Form 3160-5 (June 2019)

SUNDRY NOTICES AND REPORTS ON WELLS
o not use this form for proposals to drill or to re-enter a

6. If Indian, Allottee or Tribe Name D abandoned well. Use Form 3160-3 (APD) for such proposals. 7. If Unit of CA/Agreement, Name and/or No. SUBMIT IN TRIPLICATE - Other instructions on page 2 1. Type of Well 8. Well Name and No. RUTHLESS 11 FED COM/731H Oil Well Gas Well Other 9. API Well No. 3002547757 2. Name of Operator EOG RESOURCES INCORPORATED 3a. Address 1111 BAGBY SKY LOBBY 2, HOUSTON, TX 770 3b. Phone No. (include area code) 10. Field and Pool or Exploratory Area (713) 651-7000 WC025 G09 S253309P; UPPER WOLFCAMP 11. Country or Parish, State 4. Location of Well (Footage, Sec., T.,R.,M., or Survey Description) SEC 11/T25S/R32E/NMP LEA/NM 12. CHECK THE APPROPRIATE BOX(ES) TO INDICATE NATURE OF NOTICE, REPORT OR OTHER DATA TYPE OF SUBMISSION TYPE OF ACTION Acidize Production (Start/Resume) Water Shut-Off Deepen ✓ Notice of Intent Well Integrity Alter Casing Hydraulic Fracturing Reclamation Casing Repair New Construction Recomplete **✓** Other Subsequent Report Change Plans Plug and Abandon Temporarily Abandon Final Abandonment Notice Convert to Injection P

495' FNL 1789' FEL **Revised Wellbore**

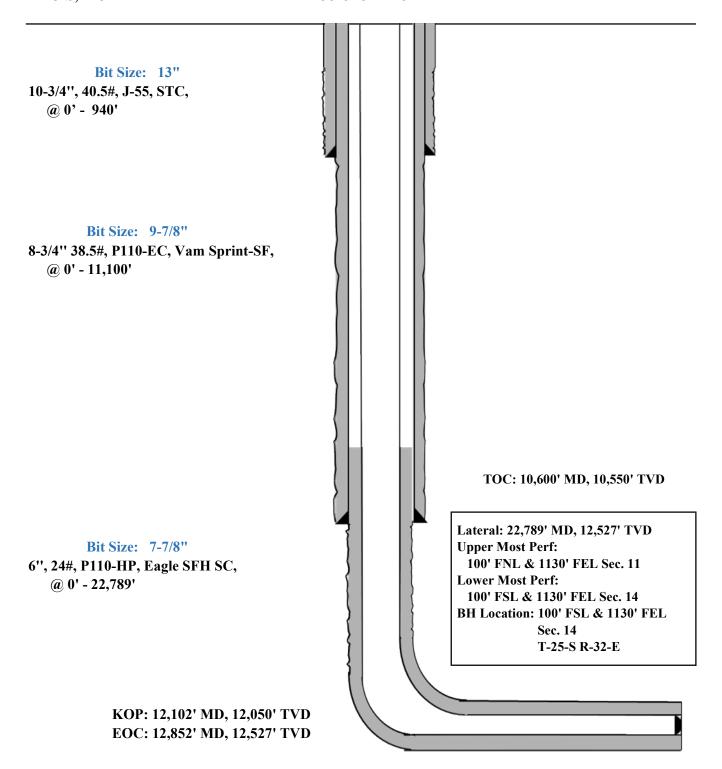
Casing Program:

Hole	Interval MD		Interva	d TVD	Csg			
Size	From (ft)	To (ft)	From (ft)	To (ft)	OD	Weight	Grade	Conn
12-1/4"	0	940	0	940	9-5/8"	36#	J-55	LTC
8-3/4"	0	11,100	0	11,050	7-5/8"	29.7#	HCP-110	FXL
6-3/4"	0	10,600	0	10,550	5-1/2"	20#	P110-EC	DWC/C IS MS
6-3/4"	10,600	11,100	10,550	11,050	5-1/2"	20#	P110-EC	Vam Sprint SF
6-3/4"	11,100	22,789	11,050	12,527	5-1/2"	20#	P110-EC	DWC/C IS MS

Variance is requested to waive the centralizer requirements for the 7-5/8" casing in the 8-3/4" hole size. An expansion additive will be utilized, in the cement slurry, for the entire length of the 8-3/4 hole interval to maximize cement bond and zonal isolation.

Variance is also requested to waive any centralizer requirements for the 5-1/2" casing in the 6-3/4" hole size. An expansion additive will be utilized, in the cement slurry, for the entire length of the 6-3/4" hole interval to maximize cement bond and zonal isolation.

Variance is also requested to waive the annular clearance requirements for the 5-1/2" casing by 7-5/8" casing annulus to the proposed top of cement.

EOG requests permission to allow deviation from the 0.422" annulus clearance requirement from Onshore Order #2 under the following conditions:

- Annular clearance to meet or exceed 0.422" between intermediate casing ID and production casing coupling only on the first 500' overlap between both casing strings.
- Annular clearance less than 0.422" is acceptable for the production open hole section.

Cementing Program:

5 5	Wt.	Yld	Slurry Description
Depth	No. Sacks	ppg	Ft3/sk	Julian y Description
940' 9-5/8''	270	13.5	1.73	Lead: Class C + 4.0% Bentonite Gel + 0.5% CaCl2 + 0.25 lb/sk Cello- Flake (TOC @ Surface)
	80	14.8	1.34	Tail: Class C + 0.6% FL-62 + 0.25 lb/sk Cello-Flake + 0.2% Sodium Metasilicate (TOC @ 740')
11,100' 7-5/8''	480	14.2	1.11	1st Stage (Tail): Class C + 0.6% Halad-9 + 0.45% HR-601 + 3% Microbond (TOC @ 7,050')
	1210	14.8	1.5	2nd Stage (Bradenhead squeeze): Class C + 3% Salt + 1% PreMag- M + 6% Bentonite Gel (TOC @ surface)
22,789' 5-1/2''	1040	14.2	1.31	Lead: Class H + 0.4% Halad-344 + 0.35% HR-601 + 3% Microbond (TOC @ 10,600')

EOG requests variance from minimum standards to pump a two stage cement job on the 7-5/8" intermediate casing string with the first stage being pumped conventionally with the calculated top of cement at the Brushy Canyon (7,254') and the second stage performed as a 1000 sack bradenhead squeeze with planned cement from the Brushy Canyon to surface. If necessary, a top out consisting of 210 sacks of Class C cement + 3% Salt + 1% PreMag-M + 6% Bentonite Gel (2.30 yld, 12.91 ppg) will be executed as a contingency. Top will be verified by Echo-meter.

Figure 1: Cameron TA Plug and Offline Adapter Schematic

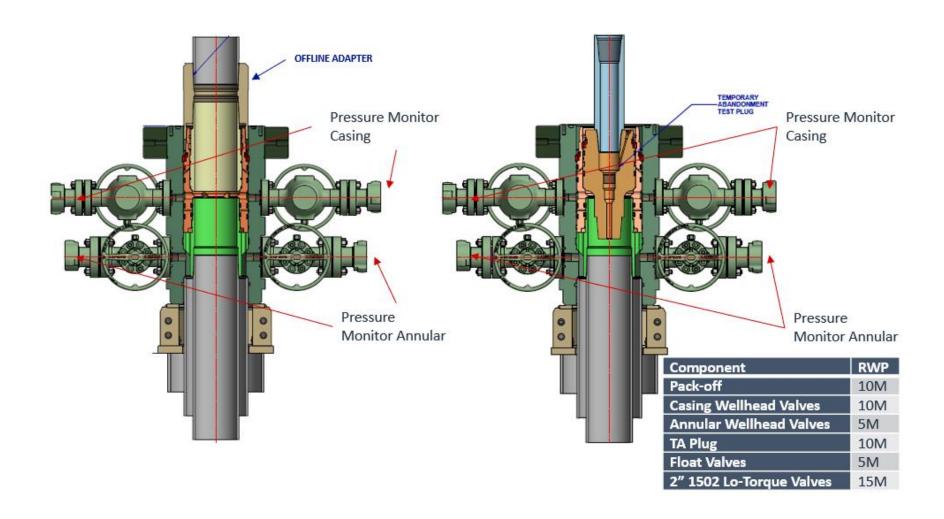
- c. Return line schematics can be seen in Figure 3.
- 10. Remove TA Plug from the casing.
- 11. Install offline cement tool.
 - a. Current offline cement tool schematics can be seen in Figure 1 (Cameron) and Figure 2 (Cactus).

Figure 3: Back Yard Rig Up

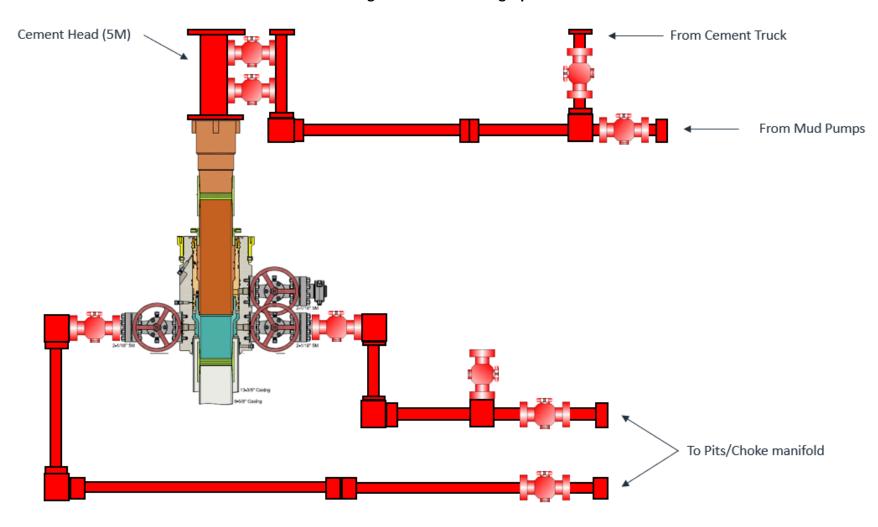
- a. Test all connections and lines from wellhead to choke manifold to 5,000 psi high for 10 min.
 - b. If either test fails, perform corrections and retest before proceeding.

Figure 4: Rig Placement Diagram

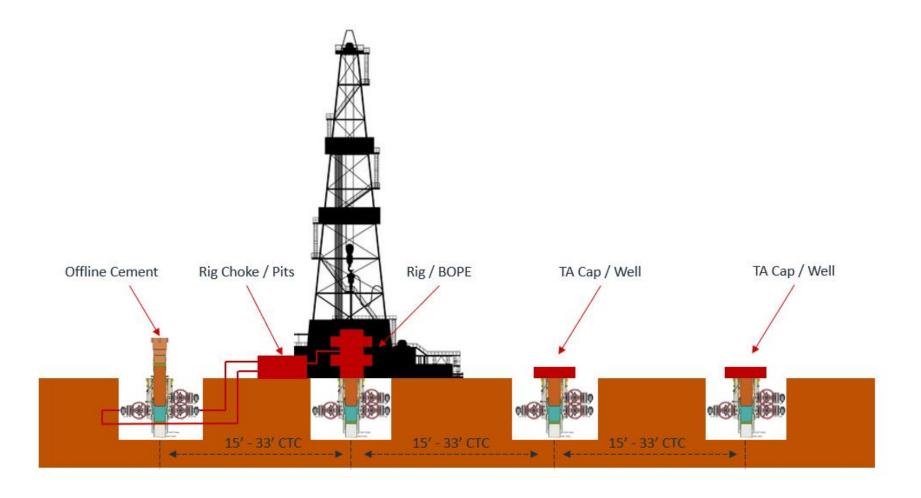
- e. Diagram for rig positioning relative to offline cementing can be seen in Figure 4.
- 9. Rig up return lines to take returns from wellhead to pits and rig choke.
